From: Dominic Page <DPPage@geraldeva.com>
Sent: 07 June 2022 12:41
To: Foster, Kevin; Jodie Farnill
Cc: Matt Claxton; Jenna Wilks
Subject: External Mail: RE: 22.00162.REM Site of Cronton Colliery.docx
Attachments: 22.00162.REM Site of Cronton Colliery.docx

Planning Consultation Response

To:	Planning Services (Planning)	
From:	Environmental Health & Consumer Protection (HB/IG)	
Planning App. No:	22/00162/REM	22/01651/PLANNI
Date:	11 April 2022	
Location:	Site Of Cronton Colliery, Cronton Road, Cronton, Knowsley, L35 1QR	
Proposal:	APPLICATION FOR APPROVAL OF RESERVED MATTERS PURSUANT TO PERMISSION 20/00494/HYB (HYBRID PLANNING APPLICATION COMPRISING: FULL APPLICATION FOR THE DEVELOPMENT OF 161,900 SQ FT (15,041 SQ M) (GIA) OF STORAGE AND DISTRIBUTION FLOORSFACE (USE CLASS B8), INCLUDING ANCILLARY OFFICES (USE CLASS B1), SECURITY GATEHOUSE, SITE ACCESS ROAD, ENGINEERING EARTHWORKS TO FORM A PART COUNTRY PARK, PUBLIC CAR PARK TO SERVE COUNTRY PARK, AND ASSOCIATED WORKS; AND OUTLINE APPLICATION WITH DETAILS OF POINT OF ACCESS (DETAILS OF PART-ACCESS, LANDSCAPING, APPEARANCE, SCALE AND LAYOUT ARE RESERVED) FOR THE DEVELOPMENT OF UP TO 838,100 SQ FT (77,862 SQ M) (GIA) OF STORAGE AND D

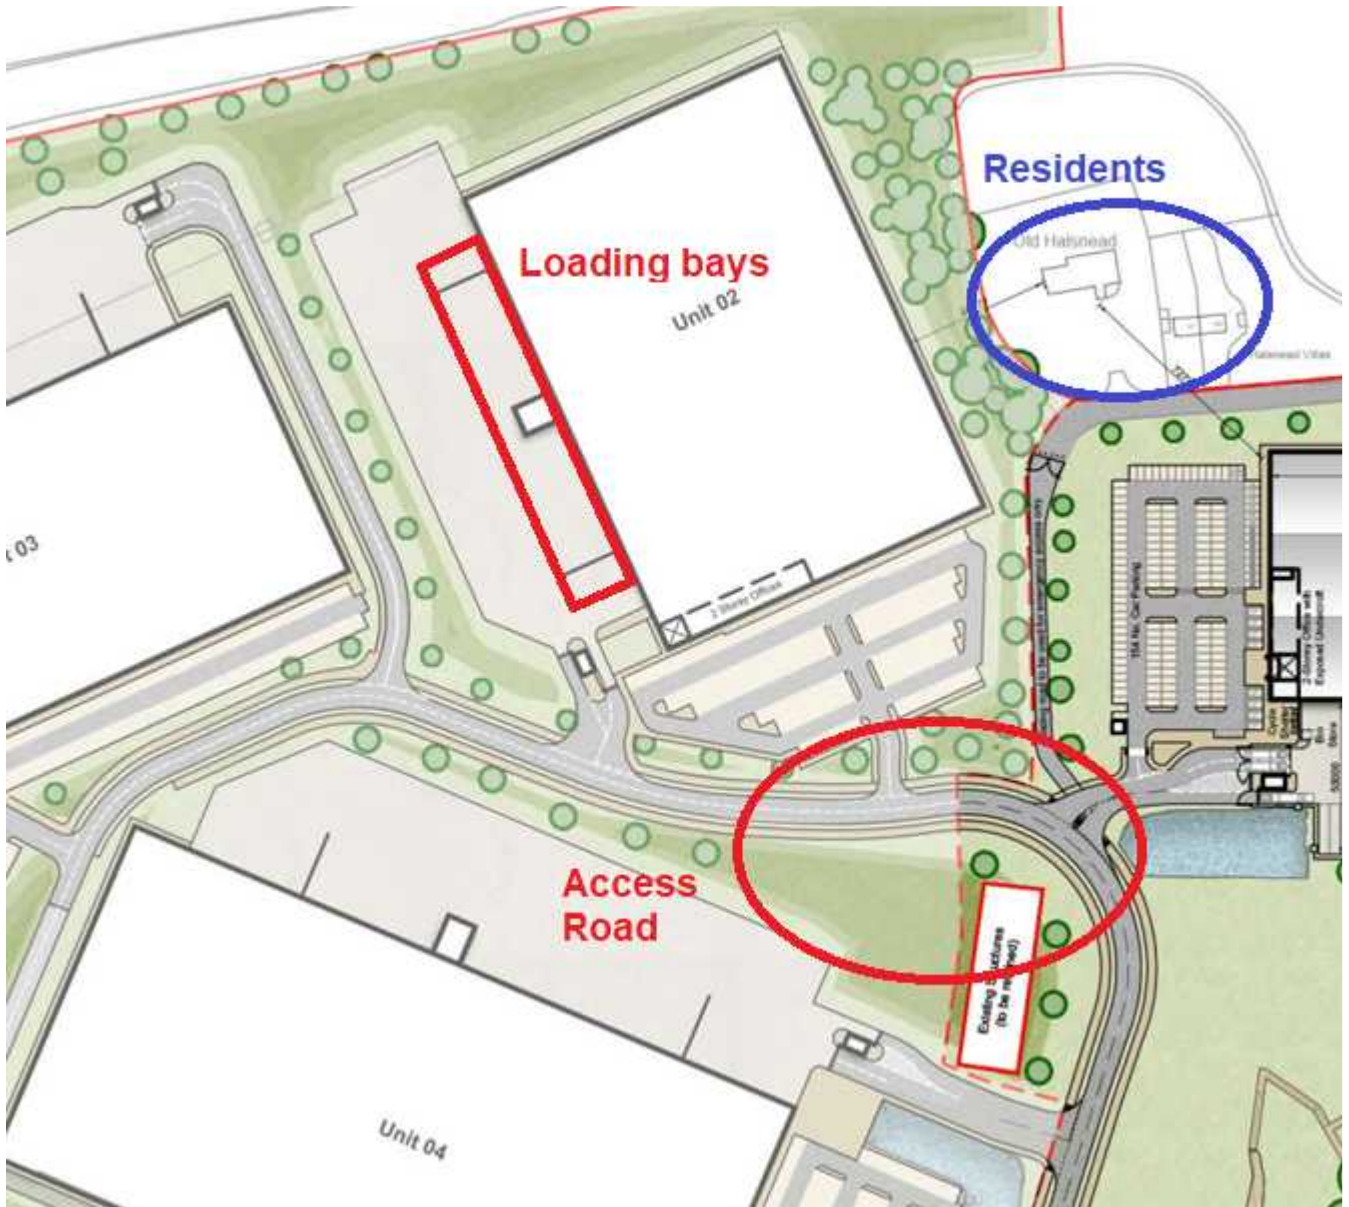
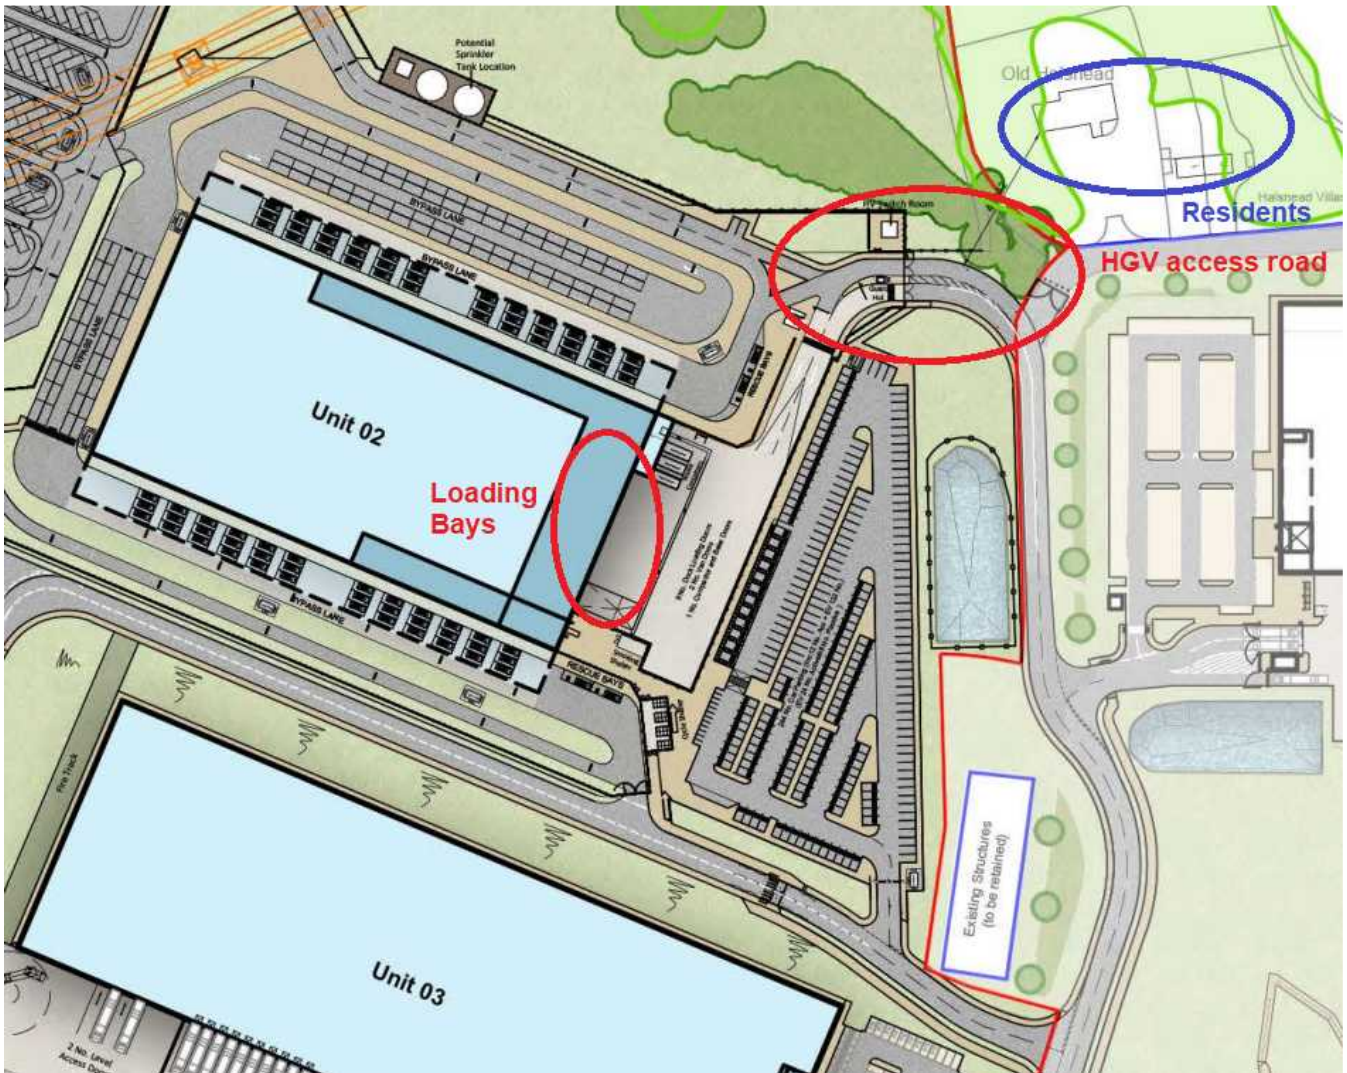
This is the main reason for Environmental Health's objection and is due to the potential for noise from this development to have a significant negative impact on the nearby residents. No objections were raised by EH previously, for 20/00494/HYB, as the layout of the site was deemed to be more appropriate. As you can see from the plan below, the loading bays for the unit were to be on a different side of the warehouse and the building itself would have acted as a barrier for the noise.

Unfortunately, the site layout has changed, and the loading bays are now on the side, closer to the residents, together with the access road – which is likely to be used by HGV's 24/7, see below.

Whilst they have stated there will be noise barriers in place at certain points, we do not believe this will be sufficient.

As the Council is aware, the proposed masterplan layout put forward with the original application was submitted for illustrative purposes only for this part of the site (i.e. the outline area). As such, the layout was not fixed by the planning permission and the Council imposed a planning condition requiring reassessment of the noise environment based on the fixed detailed proposals brought forward at the reserved matters stage, which has been submitted.

Whilst the applicant appreciates that there is a difference to the layout that could be considered less favourable from a noise perspective when compared against the illustrative masterplan, the accompanying assessment is considered to be robust (subject to the clarifications set out below) in justifying the proposed detailed layout and access arrangements.

There are also significant other benefits achieved by the RM proposals as a result of building's position at a greater distance from the Grade II listed dwelling to the north east, as well as being much smaller in scale/height. The submitted updated noise assessment has identified the requisite mitigation to ensure local residents' amenity is not unduly affected as a result of the RM scheme, which is combined with the other benefits of reduced visual impact, a greater amount of retained woodland, increased landscaping including tree planting and reduced impact on the historic environment.
